## MAGNA SEATING OF AMERICA JSP15-46

Public hearing at the request of MSA Technology Partners LLC for Preliminary Site Plan, Woodland Permit and Stormwater Management Plan approval. The subject property is located in Section 1, north of Thirteen Mile Road and east of Cabot Drive. The subject property is approximately 11.68 acres and the applicant is proposing to construct a 3-story office building, consisting of 130,000 square feet of office space, 35,000 square feet of laboratory space, and 15,000 square feet of high bay space, and associated site improvements to house the Magna Seating headquarters.

# PLAN REVIEW CENTER REPORT

**SUBJECT: Magna Seating of America  
Traffic Review for Preliminary Site Plan  
JSP15-0046**

Figure 1. City of Novi Regulated Wetland & Woodland Map (approximate property boundary shown in red). Regulated Woodland areas are shown in green and regulated Wetland areas are shown in blue).

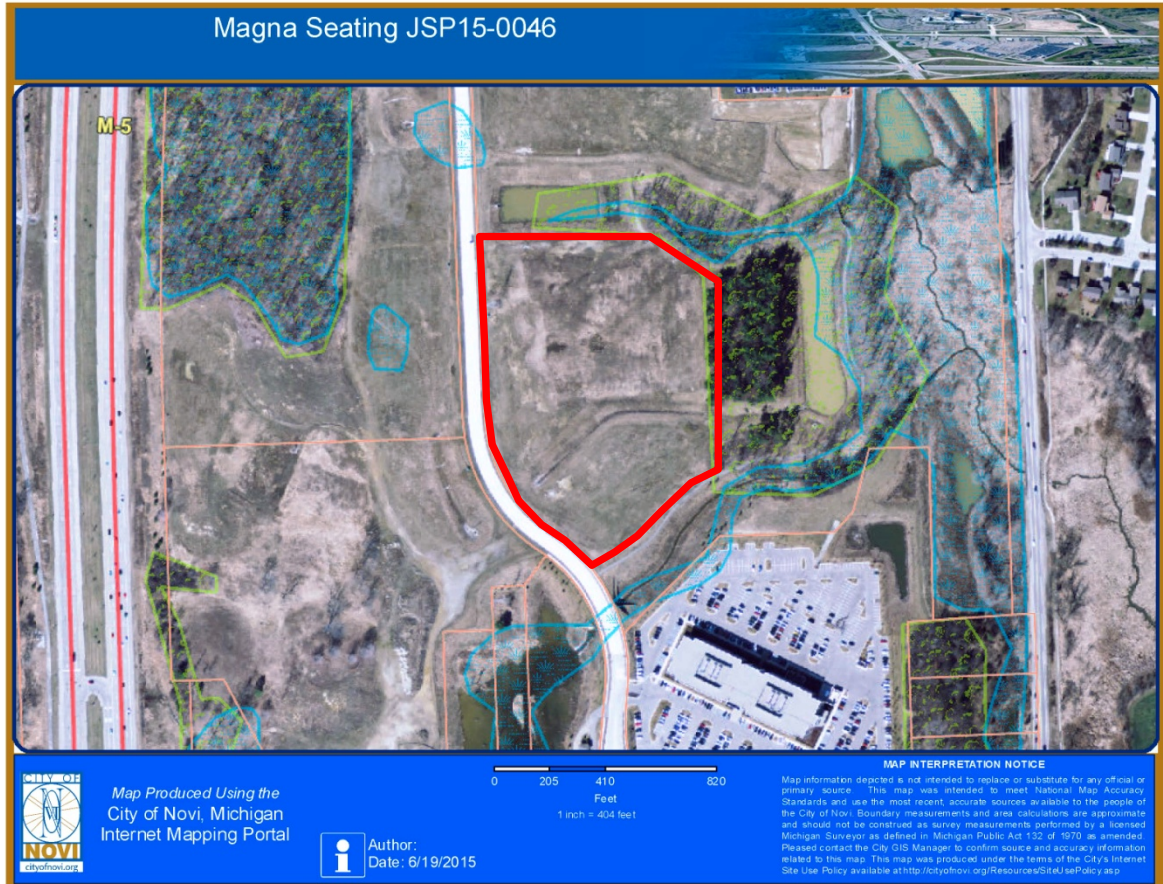
The proposed project site contains several areas of City-Regulated Woodlands but does not contain any City-Regulated Wetlands (see Figure 1).
